**Waterloo Metro Quarter Southern Precinct (SSD 10437):
Condition B11 Materials and Finishes**

Appendix A – Building 3 Student Housing Tower DRP Presentation

Appendix B – Sydney Metro DRP Advice and Actions Record

WATERLOO METRO QUARTER BUILDING 3 STUDENT HOUSING TOWER

BUILDING 3 GLAZING AND SUNSHADING FINAL DEVELOPED DESIGN

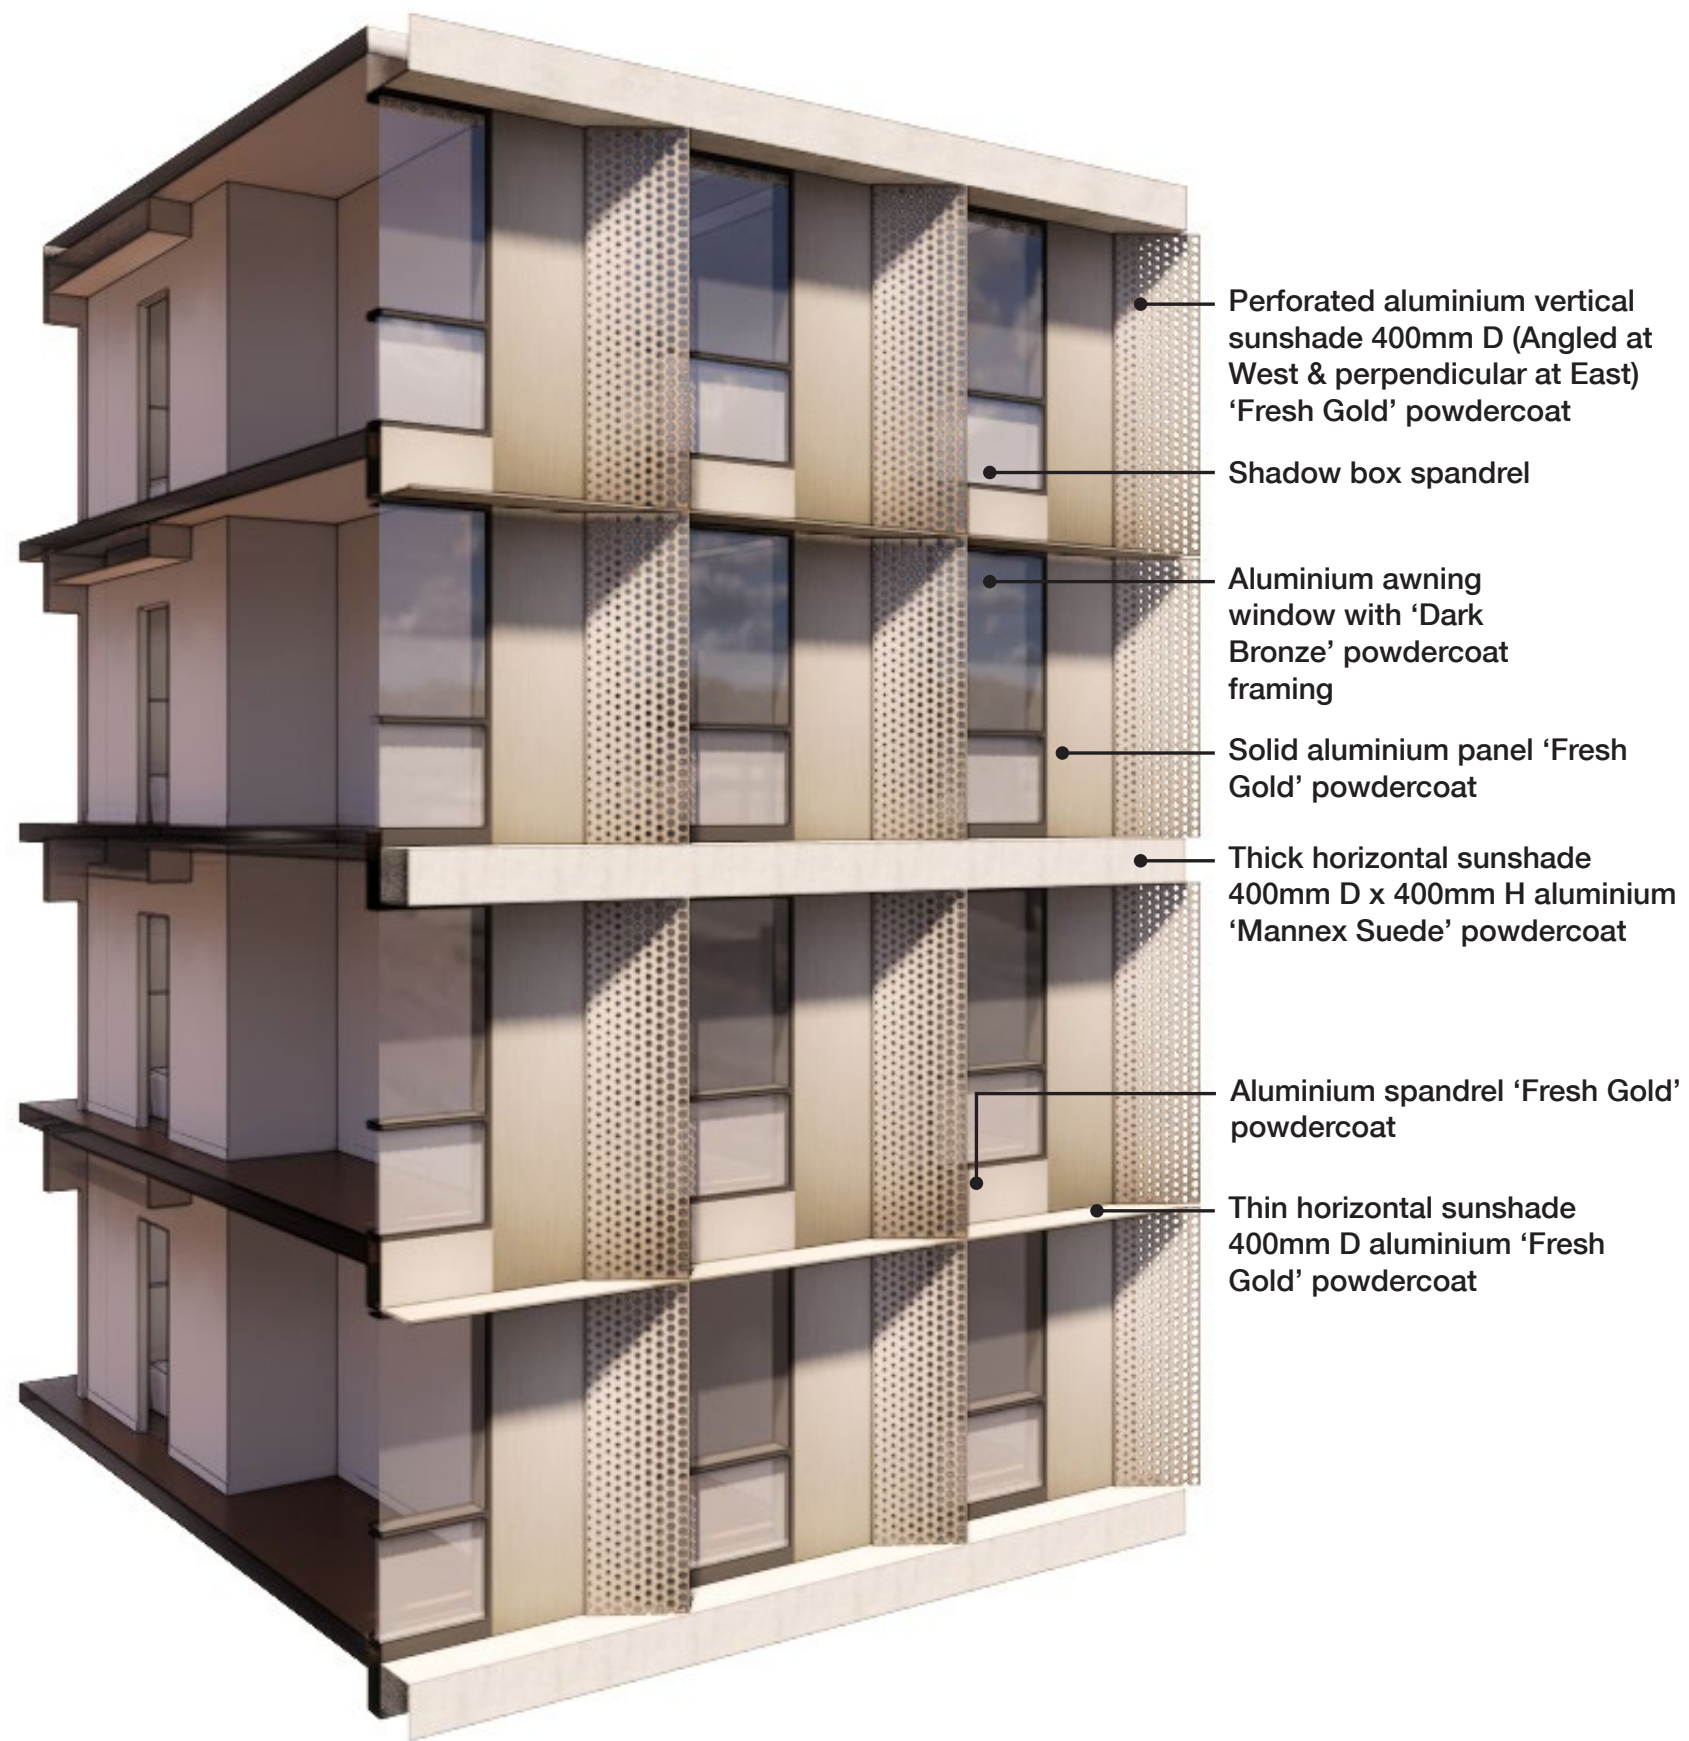
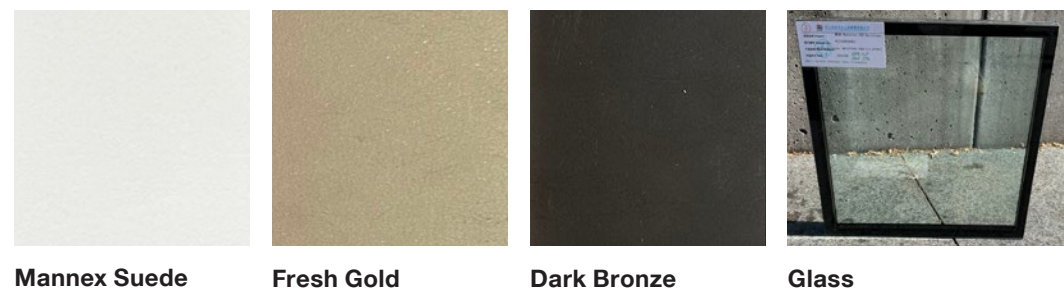
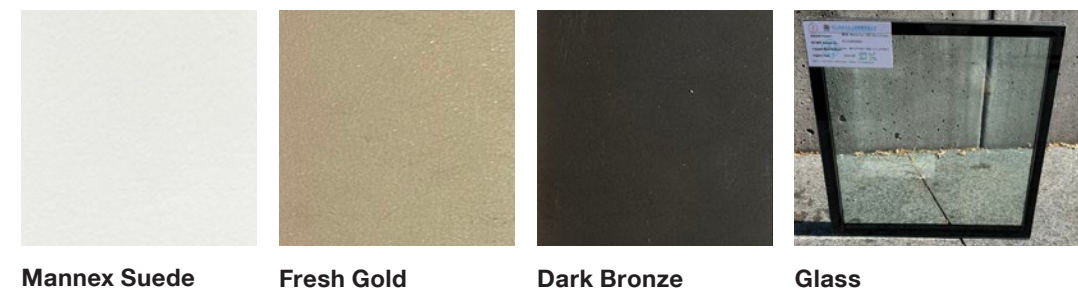
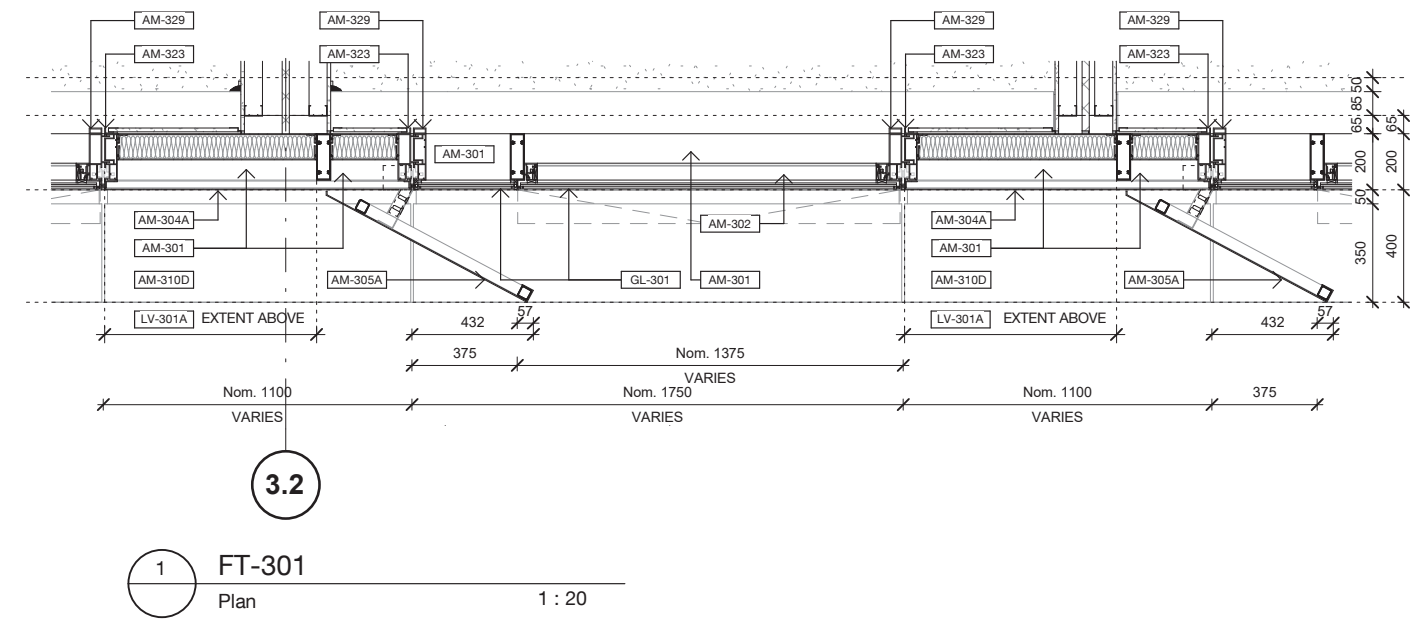
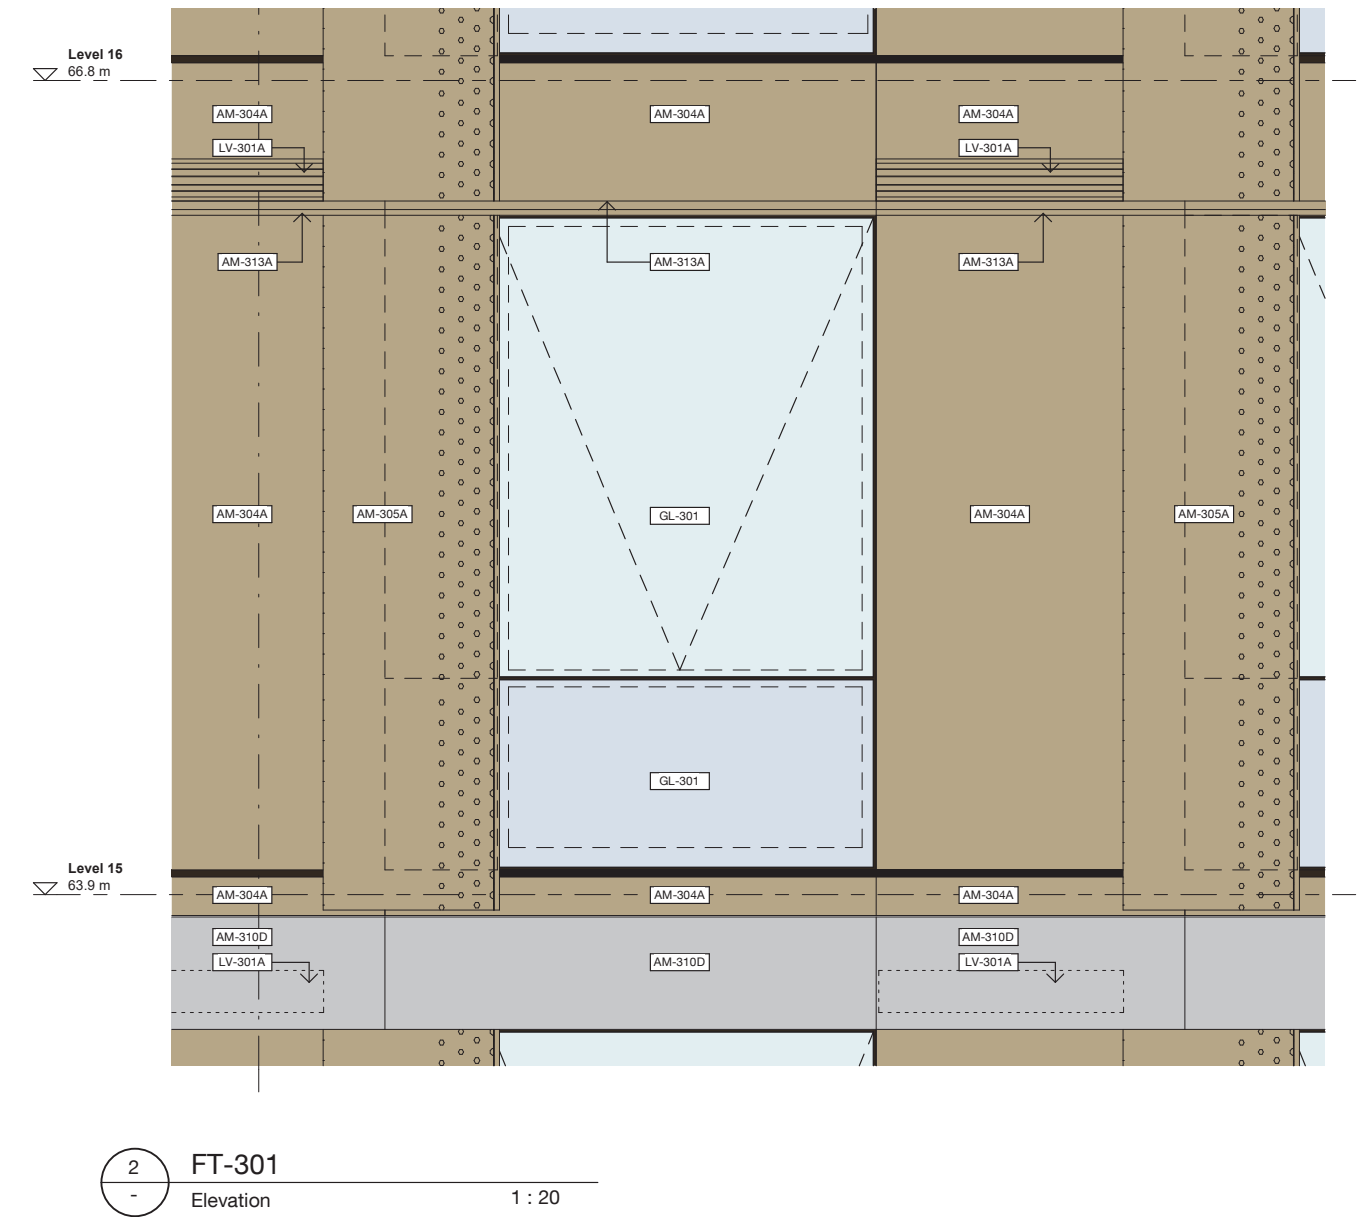
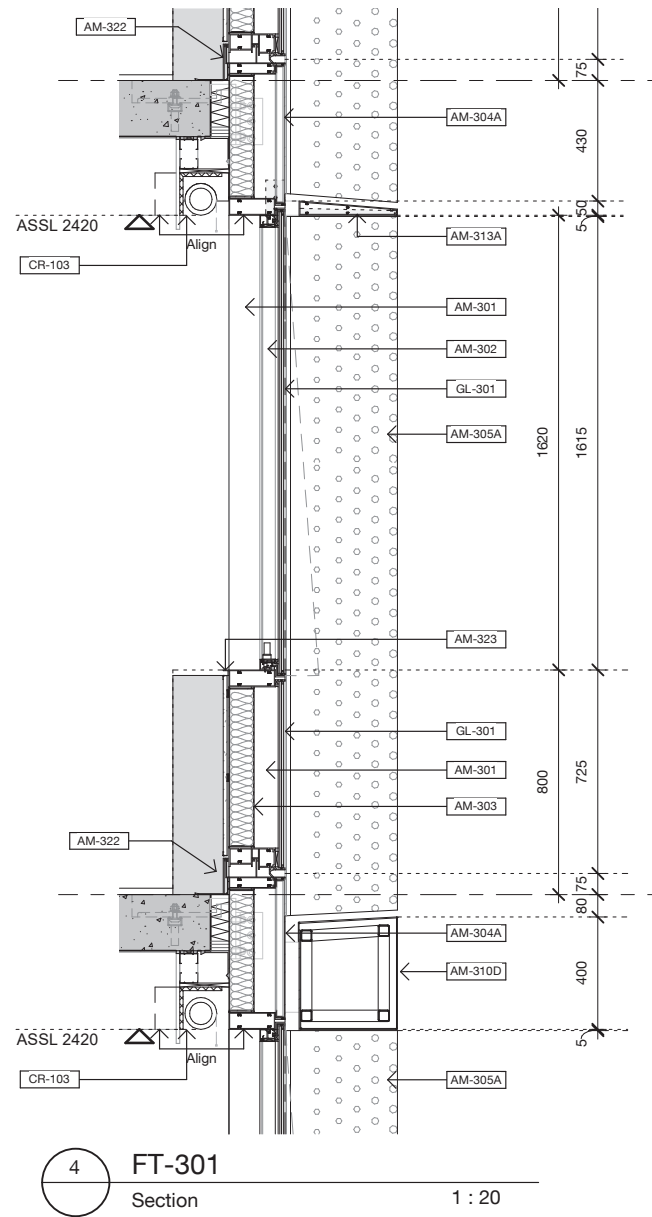
02.01	Waterloo Metro Quarter – Building 3 WDT provided an overview of the finishes proposed at SSDA and current selected façade treatment and finishes, noting that SSDA conditions stipulate that applicant must seek the advice of the DRP, prior to approval from the planning secretary. The Panel sought clarifications relating to: <ul style="list-style-type: none">• Sun penetration modelling and wind/acoustic testing on perforated sunshade• Measures to avoid staining, angled sunshade positioning and how it looks from inside the development• Confirmation that sunshade depth is consistent with SSDA• Colour differences, which may appear less pronounced on screen Comments: Panel supports the proposed materials and details and recommends: <ul style="list-style-type: none">• Technical reports to confirm the perforated sunshade meets solar protection requirements modelled, and no wind/whistling noise will be present• The design team to review colour selection once visual mock-ups are received to ensure appropriate colour contrast	WDT	Open

John Holland Building are currently undergoing the production of a Wind Generated Noise study for the façade(s) with assistance from a specialist consultant to provide a benchmark for the contractor testing, for the production of the external feature and sunshade fins.

Once prepared, the Wind Generated Noise Study will provide a base line acoustic level which the façade install contractor (Micos) will adhere to while manufacturing the fin/blades & acoustic testing regime.
